DOCKET NOS. 50-266 AND 50-301
NON-RADIOLOGICAL ENVIRONMENTAL SURVEILLANCE PROGRAM
POINT BEACH NUCLEAR PLANT, UNIT NOS. 1 AND 2

REQUEST FOR ADDITIONAL INFORMATION
REGARDING CHANGES TO
NON-RADIOLOGICAL ENVIRONMENTAL SURVEILLANCE PROGRAM
DATED JUNE 22, 1979

PLAN
POINT BEACH INTAKE
1/16" = 1'-0"

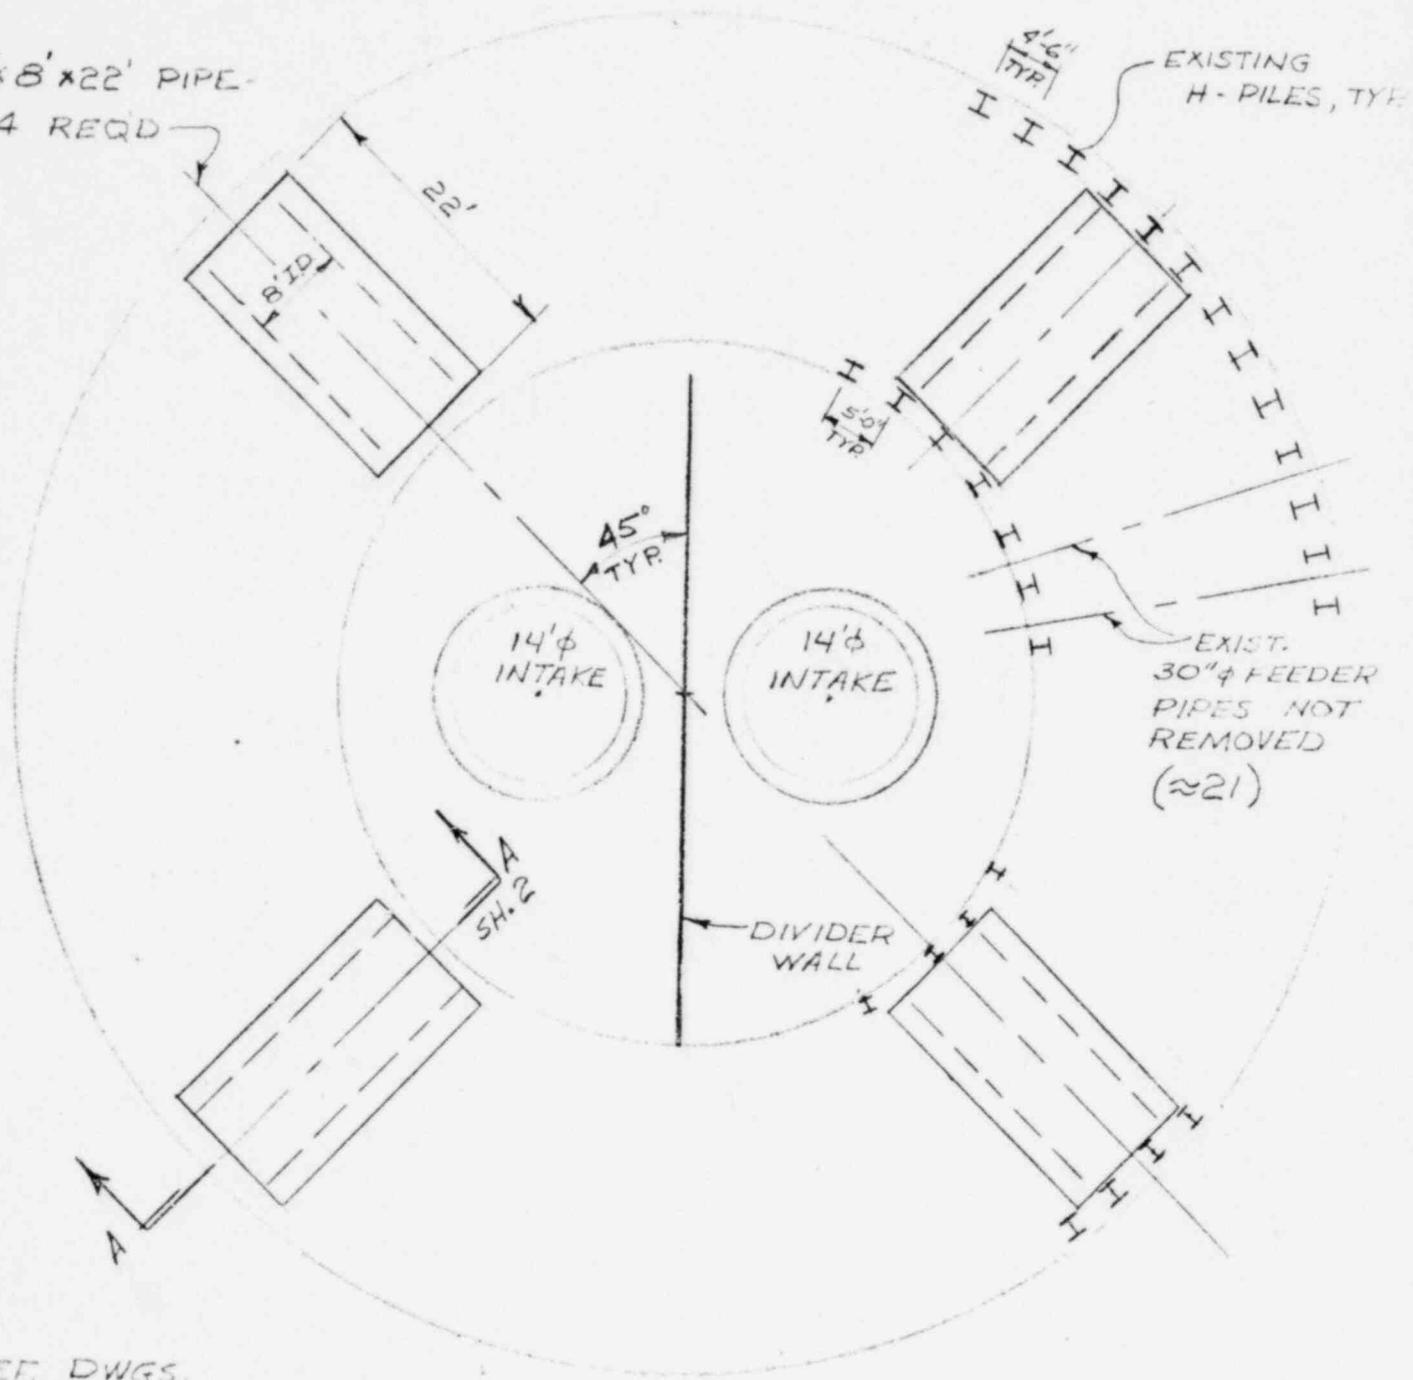
- (a) Detailed plans and design information on the new intake crib, to include drawings, differences from the present intake crib, and the estimated intake velocities under normal and maximum water withdrawal conditions.

As shown in the drawing provided in the response to Question 1.a, the intake structure is constructed by placement of large stone blocks between concentric rings of steel piling. Since initial operation, the intake structure has been regularly inspected for signs of failure, shifting stone and ice damage. During these inspections, several instances of openings of approximately one square foot have been noted between the stone blocks. However, these openings would extend through the crib only as far as the next blocks. Since the thickness of the stone section is approximately 25 feet, a large fish attempting to enter the intake would be forced to take a very irregular path. During the most recent inspection, a larger opening was found which is believed to have been caused by severe winter storms. This opening will be repaired during the intake modifications. It is possible that some fish have entered the intake through the larger opening recently identified.

The purpose of the modification is to eliminate periodic intake freezing due to frazil ice accumulation. The modification of the intake crib includes installation of up to four 8-foot square, horizontal conduits near the bottom of the crib at 90 degree intervals around the crib. The initial modification involves installation of two conduits in the south portion of the crib. If operating experience indicates that two conduits are not sufficient for preventing intake freezing, two conduits will be installed in the north portion of the crib. A sketch of the intake modification is attached. The present intake structure is detailed in Sargent and Lundy drawings B-3 and B-105, attached. The modification will not change the basic configuration of the intake crib except that 30-inch feeder pipes will be removed as necessary to accommodate installation of the conduits. The original rock will be placed around and above the new conduits. Detailed design of the conduit inlet configuration has not been completed pending investigation of the optimum inlet shape to prevent frazil ice accumulation.

8'x8'x22' PIPE -
4 REQD
